JOINT REGIONAL PLANNING PANEL

| JRPP No | 2013HCC021 |
| Proposed Development | Mixed Use Development, Residential Flat Buildings, Small Lot Housing, Stormwater Management Facility, Roads and Subdivision |
| Report by | Elizabeth J Lambert, Senior Development Planner, Lake Macquarie City Council |

Figure 6: Eastern elevation of Building B on Lot 1

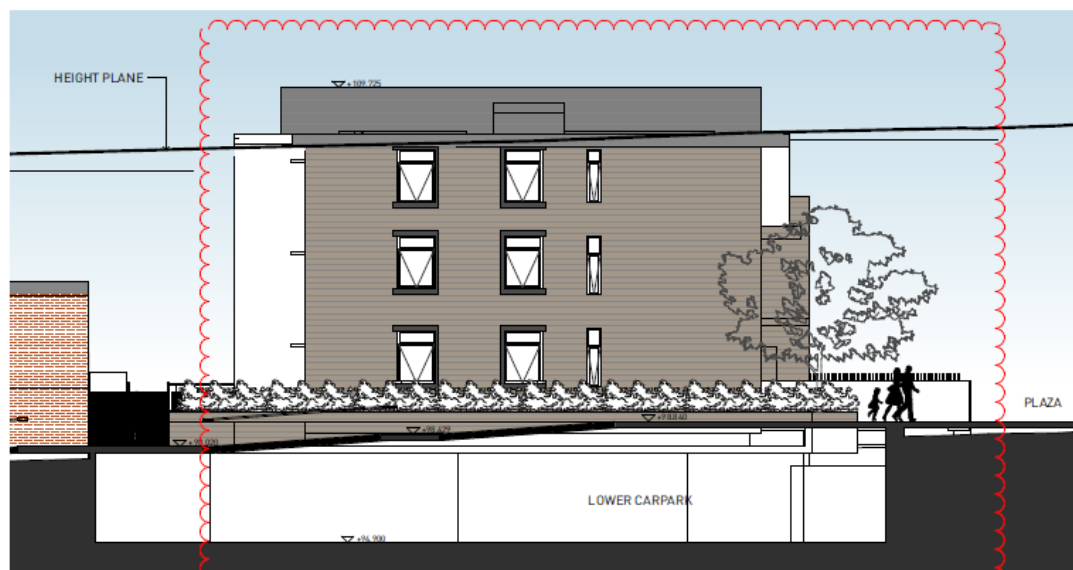
Figure 1 above shows the RL at the top of the building, as originally proposed, is 110.826. The RL at the upper most point of the building as proposed through this amendment that is with the lowering of finished floor levels is RL109.725, resulting in a height reduction of 1.101m compared to the previous proposal (see Figure 1 above). The strengths in this proposal is the reduction in height whilst maintaining unit numbers and providing an appropriate built form to Dudley Road and other areas as evidenced in the elevations shown in Figures 4, 5, 6 and 7 below.

Figure 9: Shadow cast by development at 12noon on 21 June, with the red showing the additional shadow cast by that part of the building above the 10m height plane.

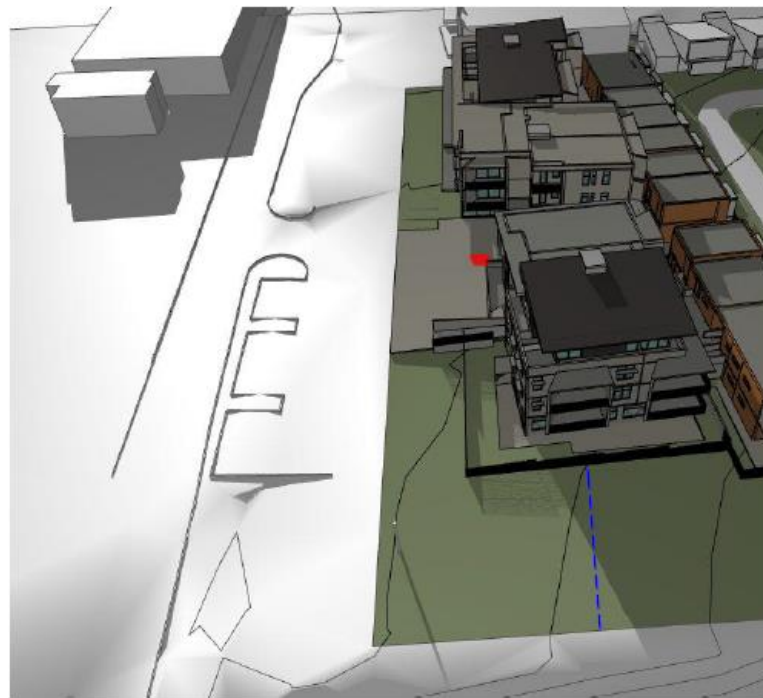
Shadow diagrams have been provided demonstrating the shadow cast to Dudley Road; refer to Figures 8 to 11 below. The shadows from the development extend approximately to the middle of the road and do not extend to the kerb on the southern side of Dudley Road. The shadow diagrams provide in RED the additional shadow cast from the buildings above the 10m height plane. The shadow cast at 9:00am in mid-winter is also shown in plan view in Figure 11 below.

Figure 12: Amended interior layout of apartment A001

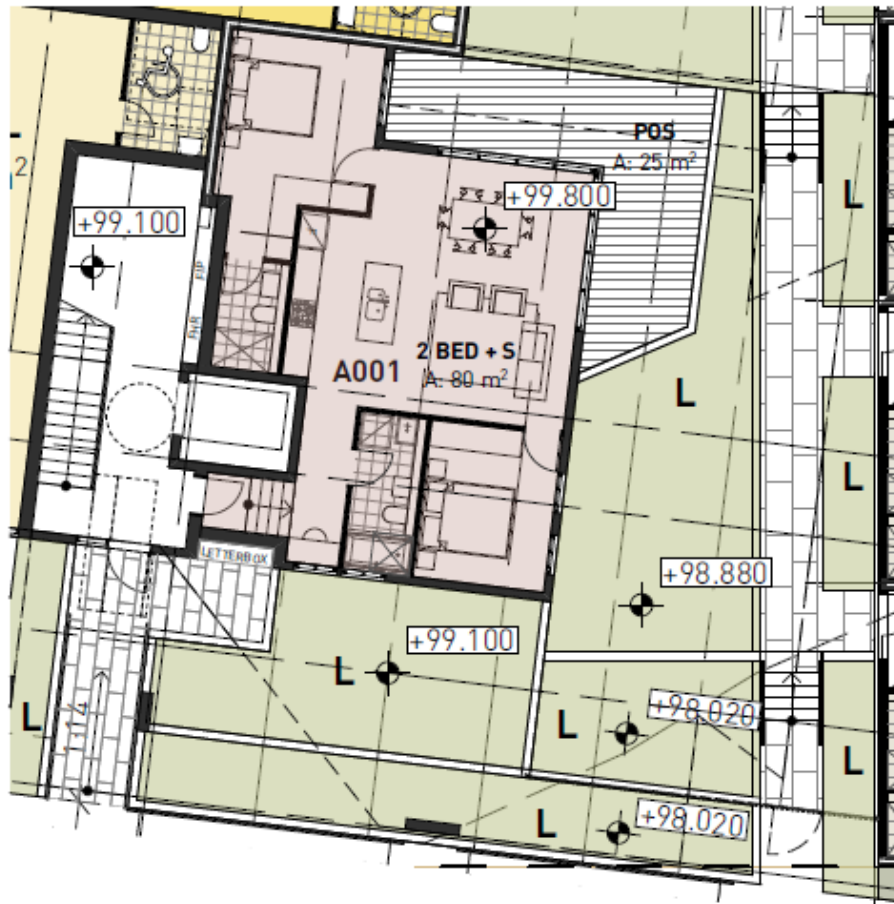
The amenity of the ground floor apartment A001 has been improved through a redesign, as shown in Figure 12 below. Redesign has allowed greater solar penetration into the living areas and private outdoor open space. The common open space between the maisonettes and the apartment building also receives improved solar access.

Figure 14: Car parking spaces (11) located at the front of Lot 1 provided for the commercial / retail component of the development

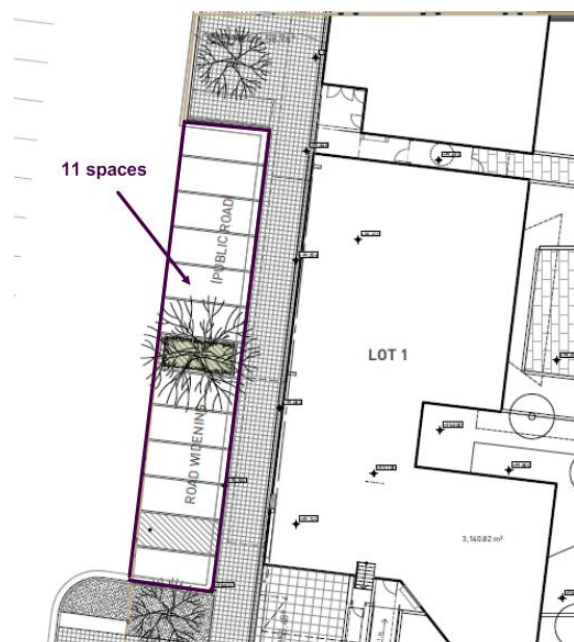
The development proposes 131m² of retail floor space. Using the retail parking rate of 1 space per 25m², a total of 5.24 parking spaces are required. The development also proposes 194m² of commercial floor space. Using the commercial parking rate of 1 space per 40m², a total of 4.85 parking spaces are required. A total of 10 car parking spaces are required for the non-residential component of the development. 11 parking spaces (including 2 disabled spaces) are proposed as angle parking at the front of the site, providing a surplus of one space in this area as shown in Figure 14 below.

Figure 15: Plan of Dudley Road area showing 18 parking spaces

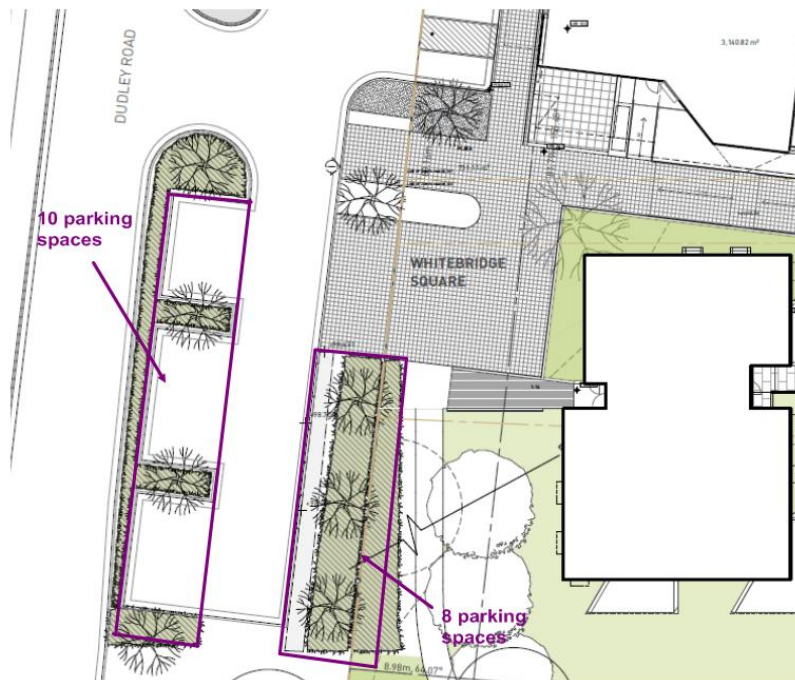
There are an additional 18 parking spaces located within the Dudley Road road reserve fronting Building B and shown, as the areas outlined by purple, in Figure 15, which creates a 19 space surplus (including the additional parking space from the 11 spaces shown in Figure 14 above).

The total visitor parking deficiency is 17.25 spaces. These 18 parking spaces are provided at the southern end of the Dudley Road service road. To accommodate visitor parking the development proposes the construction and dedication to Council of the parking areas outlined in purple shown in Figure 12 and those spaces showing in Figure 11.
